ISSUE: Permit to Demolish/Capsulate (partial)

APPLICANT: Ashley F. & Ryan J. Carmen

LOCATION: Old and Historic Alexandria District
919 Cameron Street

BAR2025-00294

Figure 1 - Existing rear/north elevation

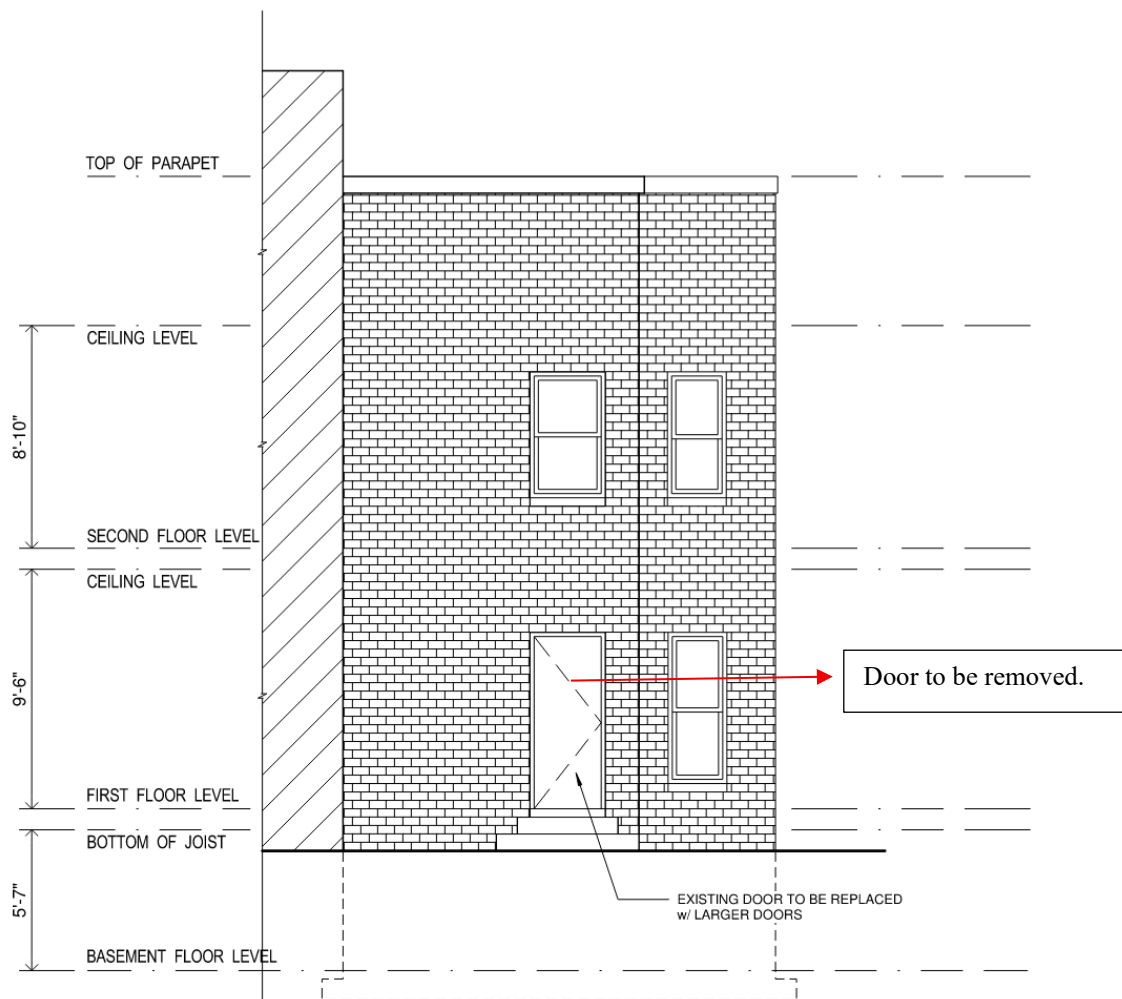
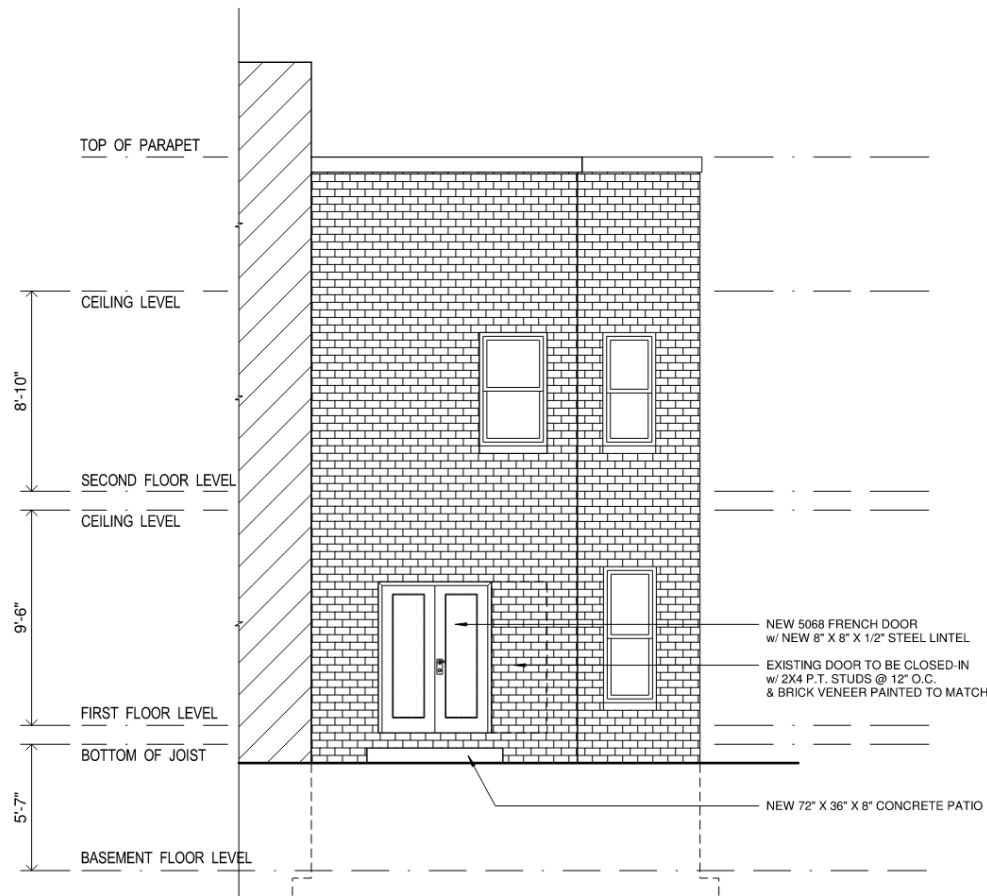
The applicant requests a Permit to Demolish/Capsulate to demolish approximately 64 square feet of the building's north/rear elevation to add a pair of French doors and infill the existing door opening with brick to match the wall, approximately 21 square feet (Figure 1 and 2), at 919 Cameron Street.

The analysis of the standards indicated above relate only to the portions of the wall area proposed for demolition/capsulation. In the opinion of staff, none of the criteria for demolition and capsulation are met and the Permit to Demolish/Capsulate should be granted. The area to be demolished is only 64 square feet not visible from a public way. Furthermore, the Board routinely approves changes to the rear of historic buildings to accommodate a more modern and functional interior layout as tastes and technology evolve.

Staff recommends approval of the Permit to Demolish/Capsulation as submitted.

**PROPOSED
REAR ELEVATION**
SCALE 1/4" = 1'-0"

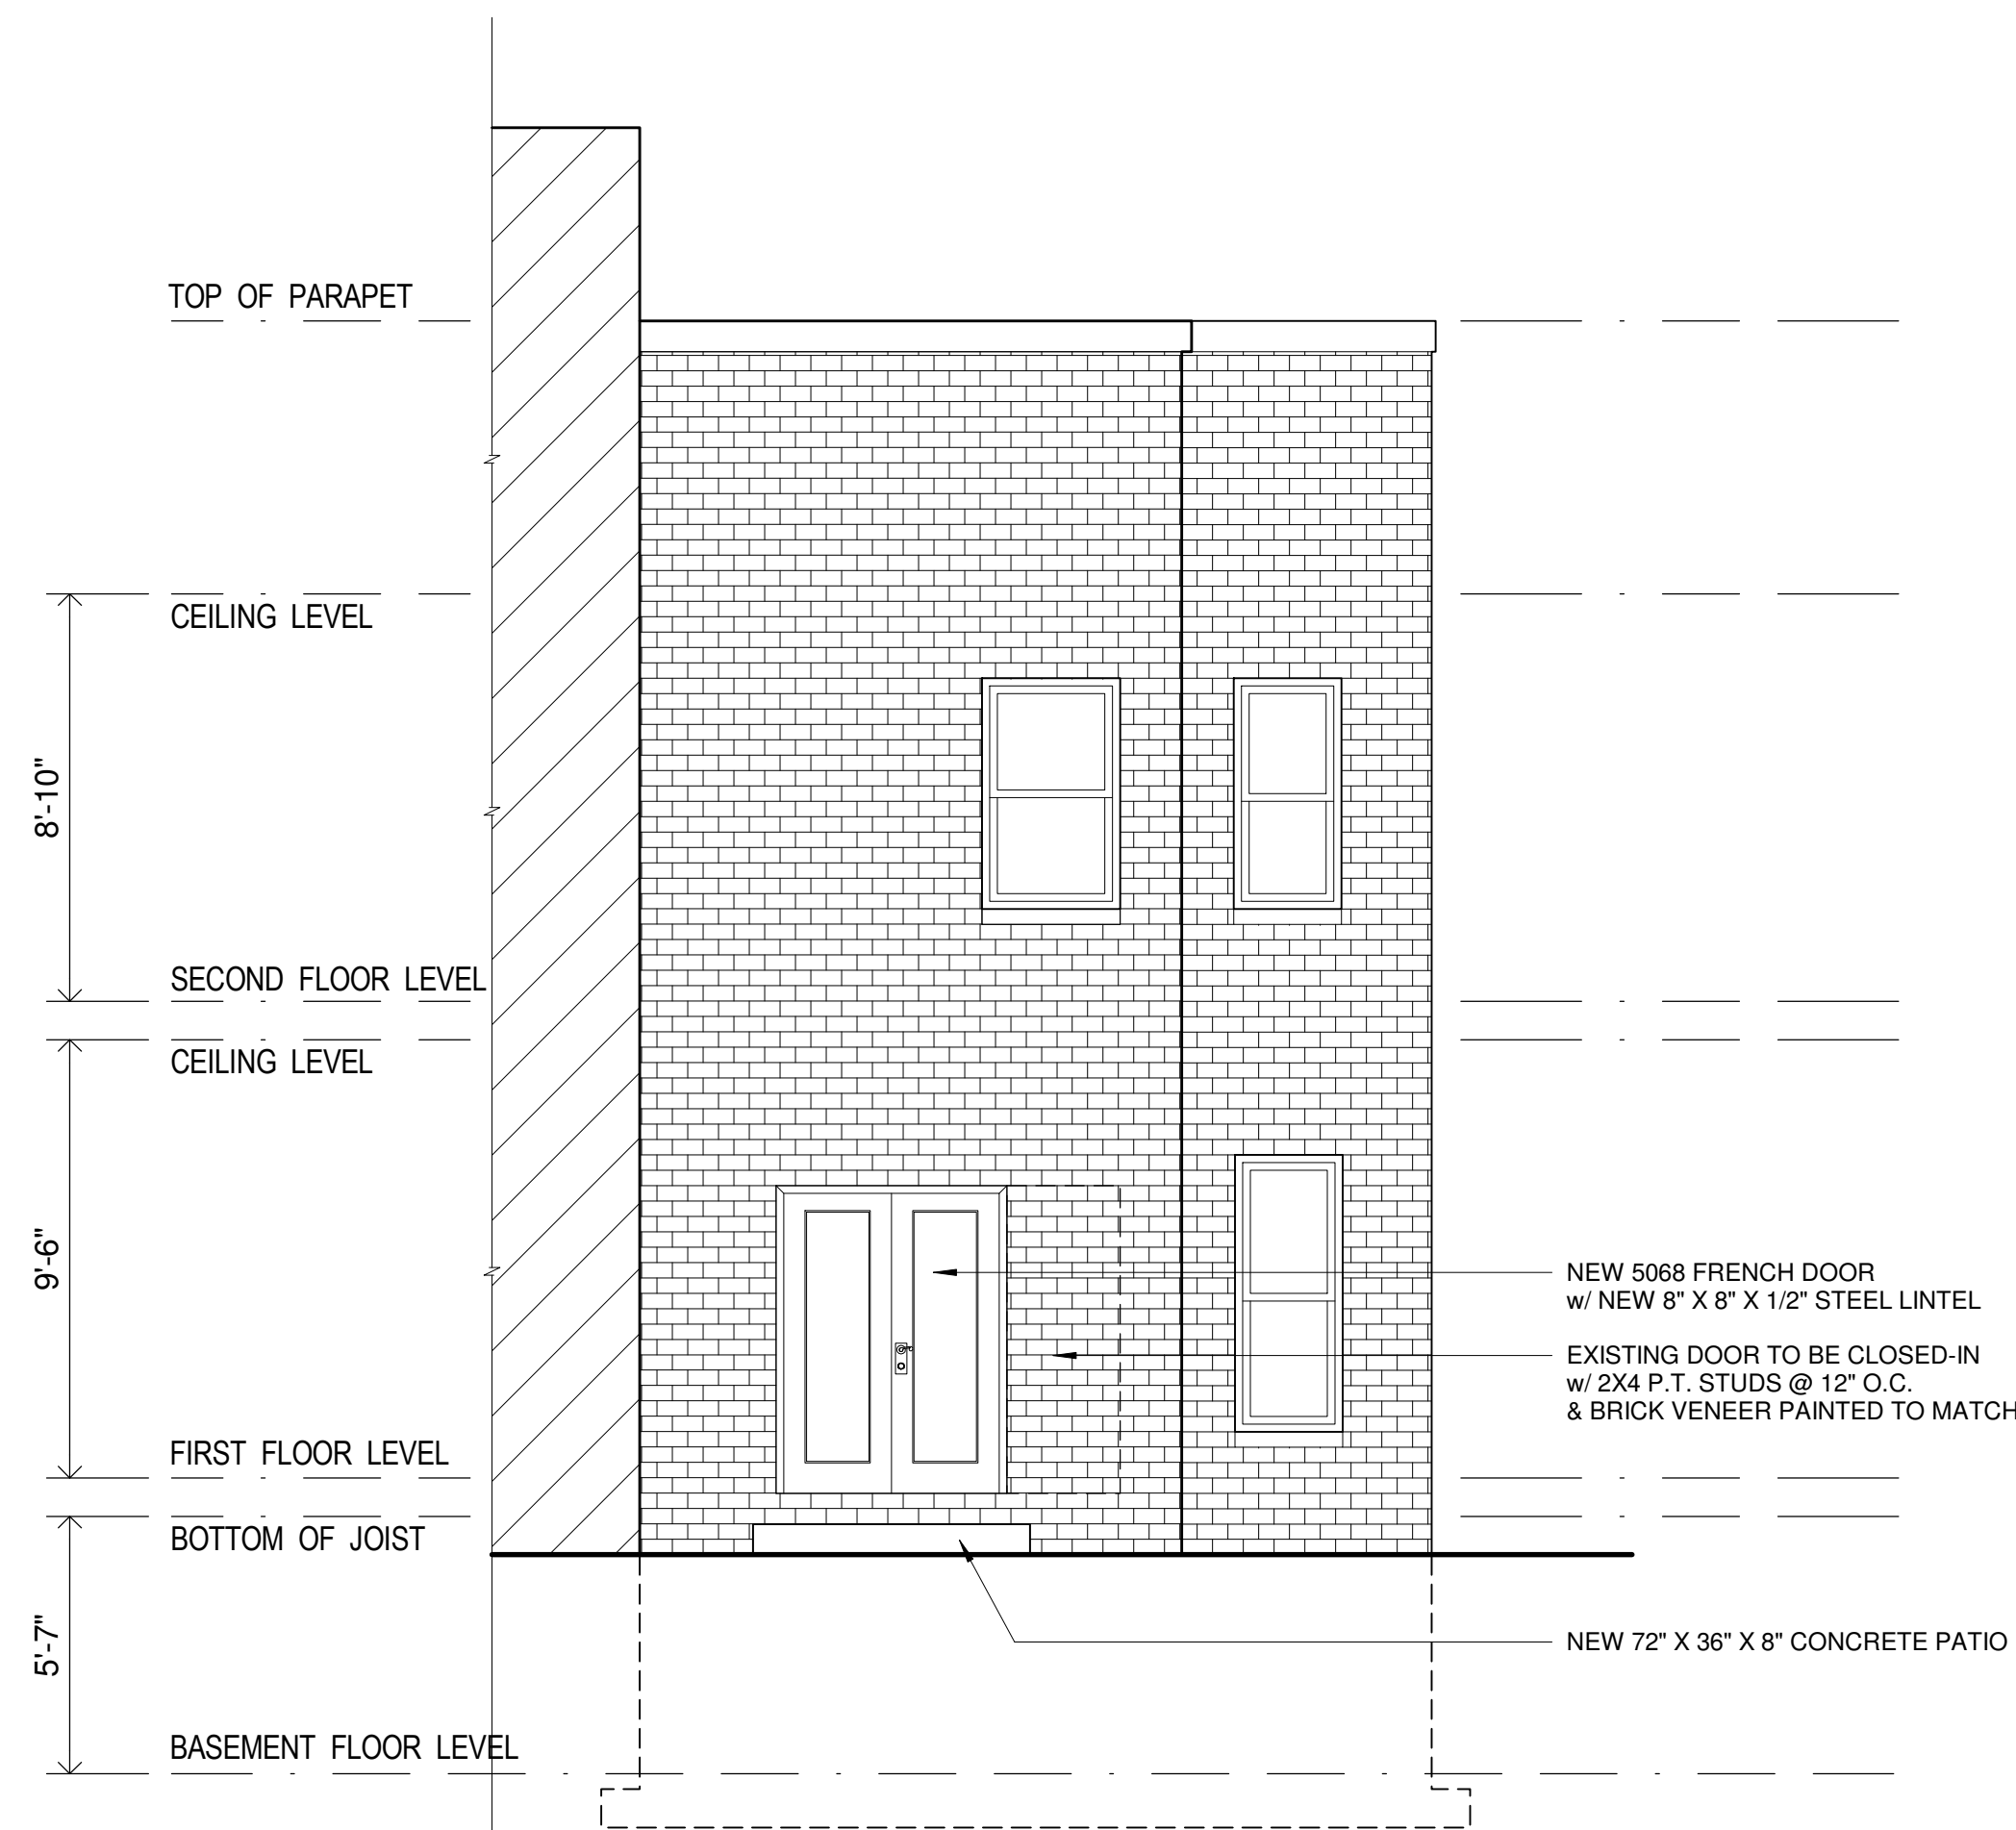
C-1 Proposed new door and demo of rear wall will comply with Zoning.
